PERCY-TERRY RESUBDIVISION

APPLICATION NUMBER 1 DATE January 21, 2016

APPLICANT Percy-Terry Subdivision Resubdivision of

REQUEST Subdivision

DETAIL SITE PLAN

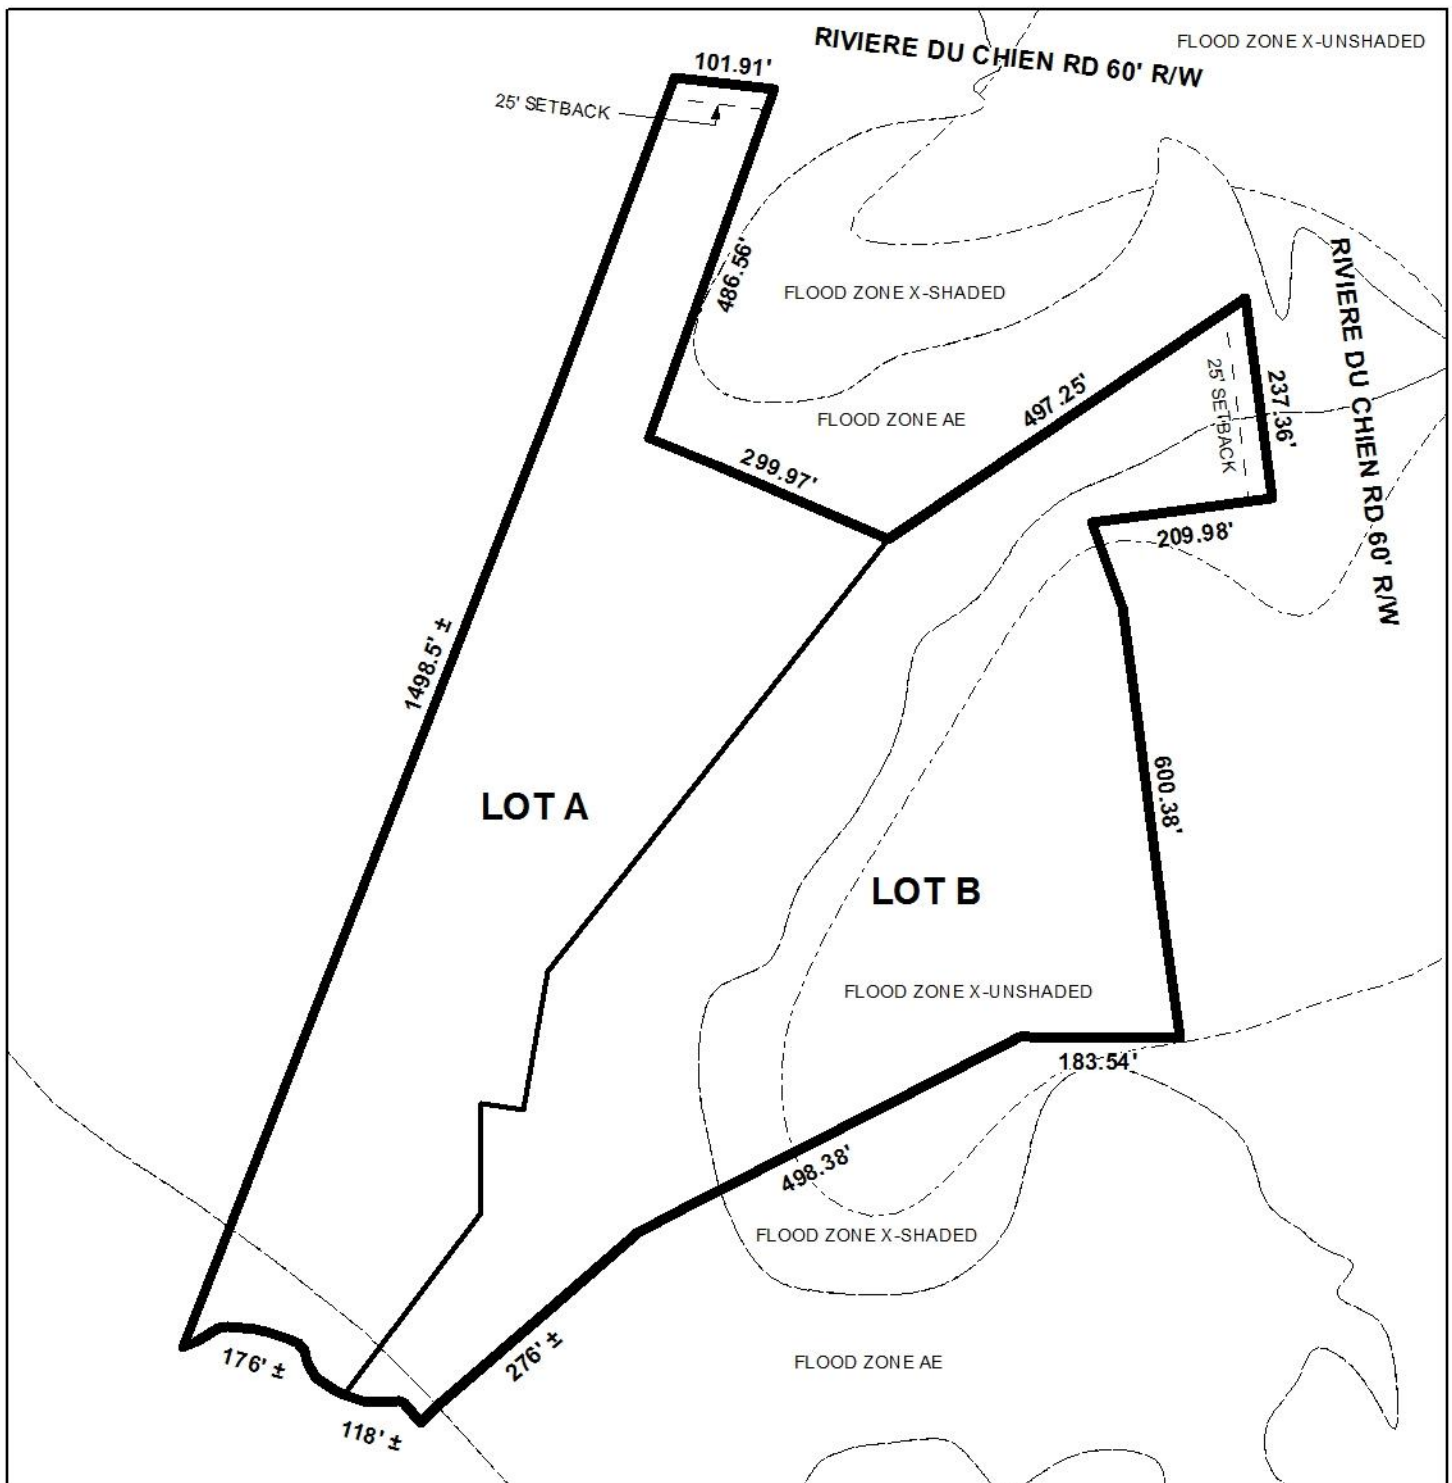
2. Review the written legal description to see if an additional bearing and distance should be inserted near the SE corner of LOT B between the end of the meanderings of the creek and the OTF (1/2" Open Top Pipe Found).

3. Review the need for a witness monument(s) along Halls Mill Creek and the channel up to the existing boat house.
4. Provide and label the monument set or found at the SE corner of LOT B, southwest of the OTF subdivision corner.

It should be noted that the proposed subdivision will result in an existing boat house crossing property lines. If approved, the boat house straddling this lot line must be moved to meet side and rear setback requirements. If the structure or lot line cannot be moved to comply with Zoning Ordinance setback requirements due to the geography of the tributary to which it is proximal, the boat must be demolished.

Legal counsel has advised that, since the subdivision request is not altering the existing property line through the existing boat house, thus not creating a new violation, the request should be considered for approval.

- 4) adjustment of the lot line so the existing boat house complies with Zoning Ordinance setback requirements, or attainment of all necessary permits to either relocate or demolish the structure, prior to signing of the Final Plat;
